RE: Damroth Subdivision / "OLD FIELD'S PATH"

MVC Building Envelope Plan

Plan of Land in
Chilmark, Mass.

Prepared for
David A. Damroth

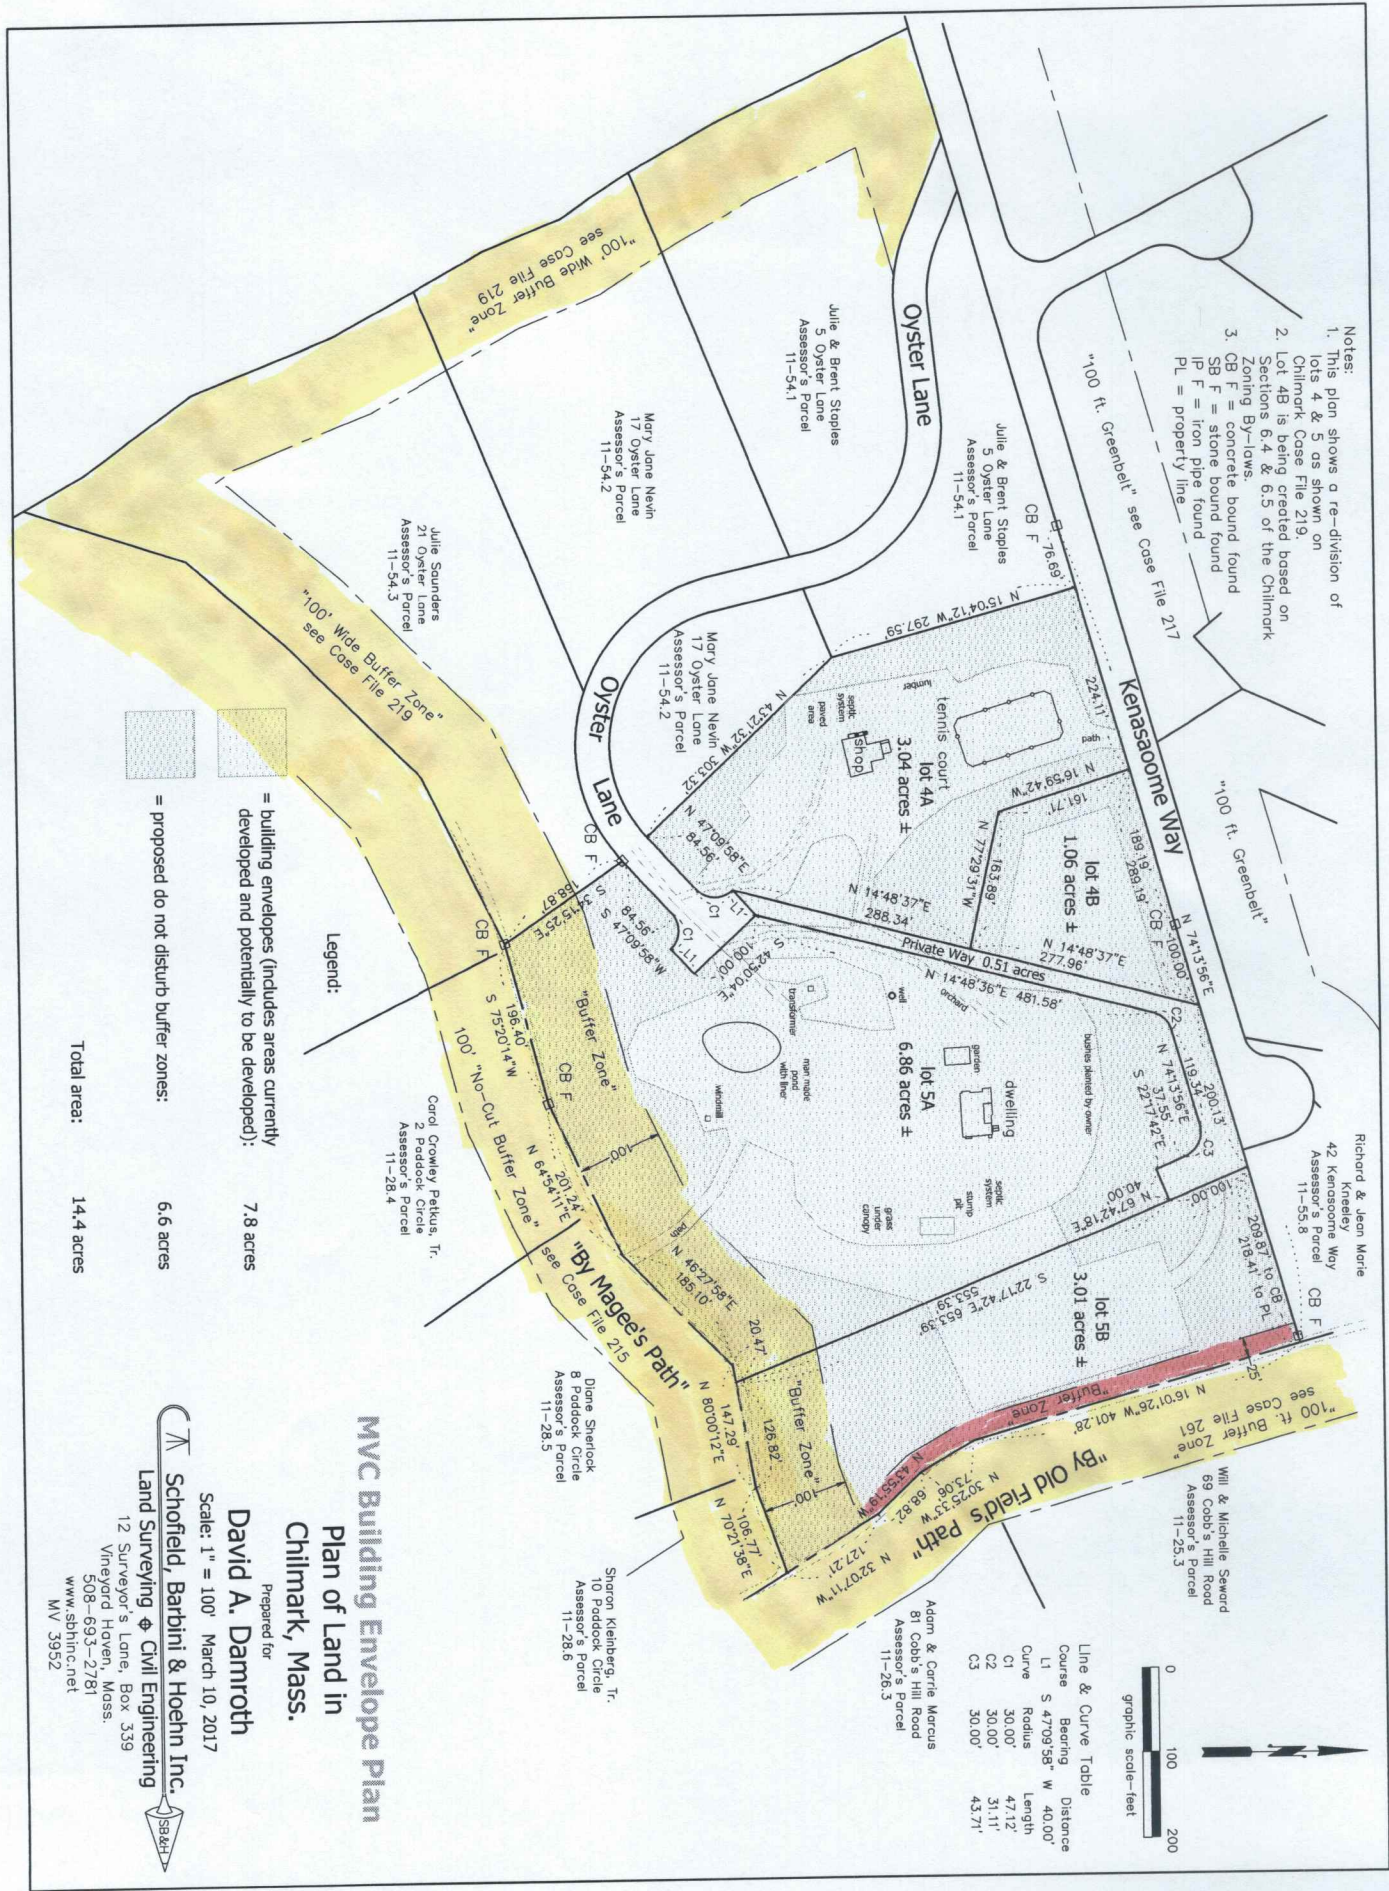
I am writing to follow up on my letters to both CPB and MVC (on behalf of myself and the Marcuses) regarding the proposed Damroth subdivision and Lot 5B, in particular. I have reviewed the March 9, 2017 MVC Hearing and the attached March 10, 2017 MVC Building Envelope Plan (the "Plan") requested by the MVC that David Damroth has now submitted. I am writing to object, categorically, to its approval by the Martha's Vineyard Commission and Chilmark Planning Board based on the lack of a 100' buffer zone along "OLD FIELD'S PATH" on the eastern border of the property (see attached drawing).

As my father, David Seward stated for the record in the MVC hearing on March 9, our only issue is the Plan's absolute disregard for OLD FIELD'S PATH by marking only a 25' set back from the path, the protection of which was required by the CPB during the 1991 Cobbs Hill subdivision. We note: the new plan calls for a 100' buffer zone on the south border "BY MAGEE'S WAY".

standards for protecting such historic ways be applied uniformly to all subdivisions. We believe that both goals can be accomplished here.
